LCDXN4/0-38D-X
Copper Lug - Narrow Tongue, Two-Hole, Standard Flex Barrel

SCALE N/A DRAWING NO / CAD FILE LCDXN4_0-38D-CUST

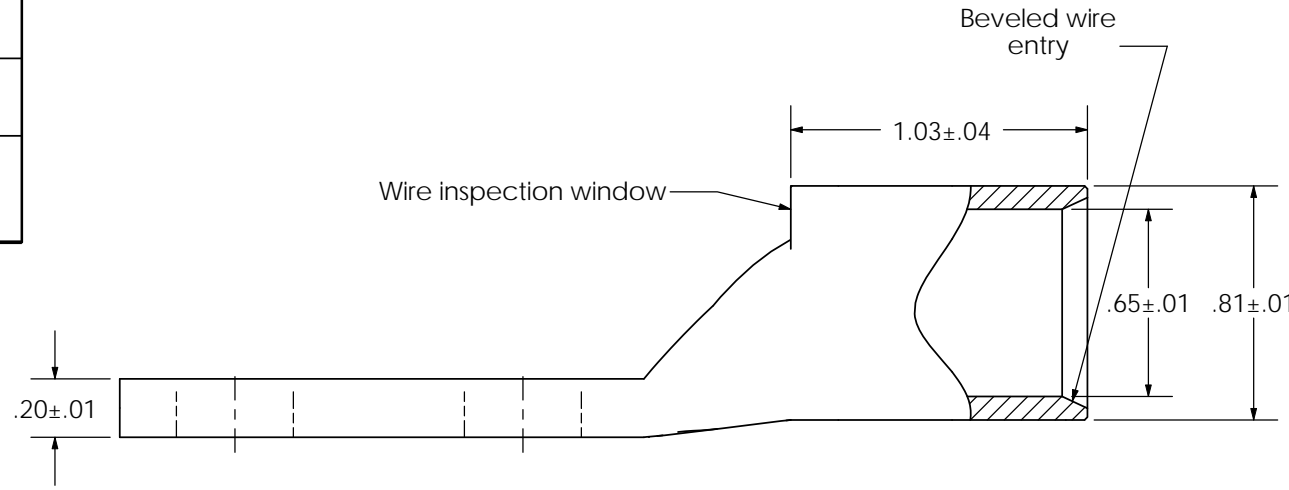
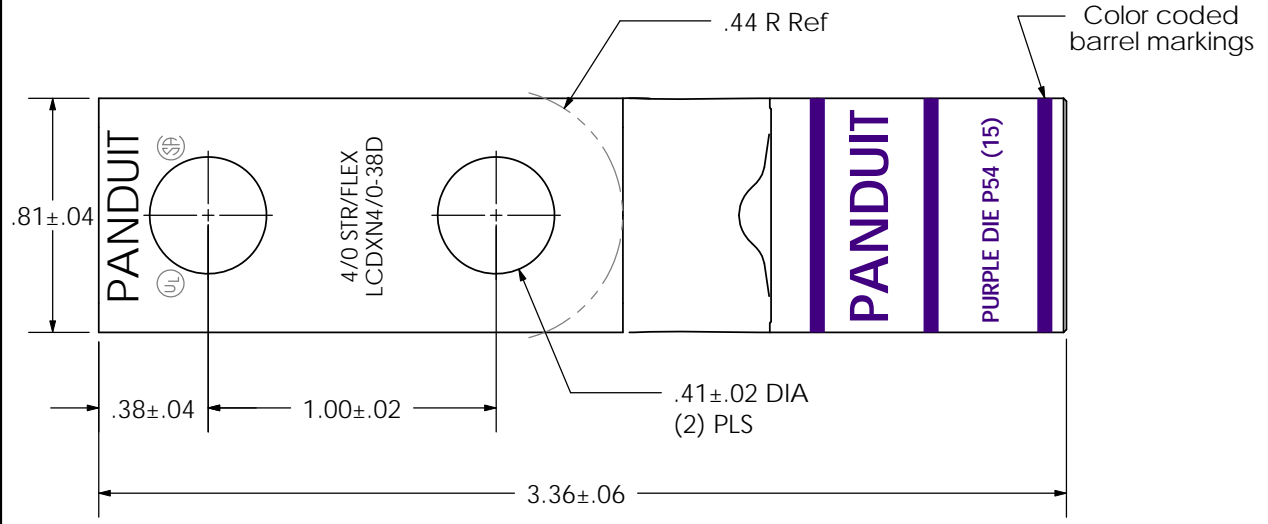
02	1/11	JHNU	JHNU	REVISED OVERALL LENGTH: WAS 3.34 REVISED TONGUE THICKNESS: WAS .16	
REV	DATE	BY	CHK	DESCRIPTION	ECN
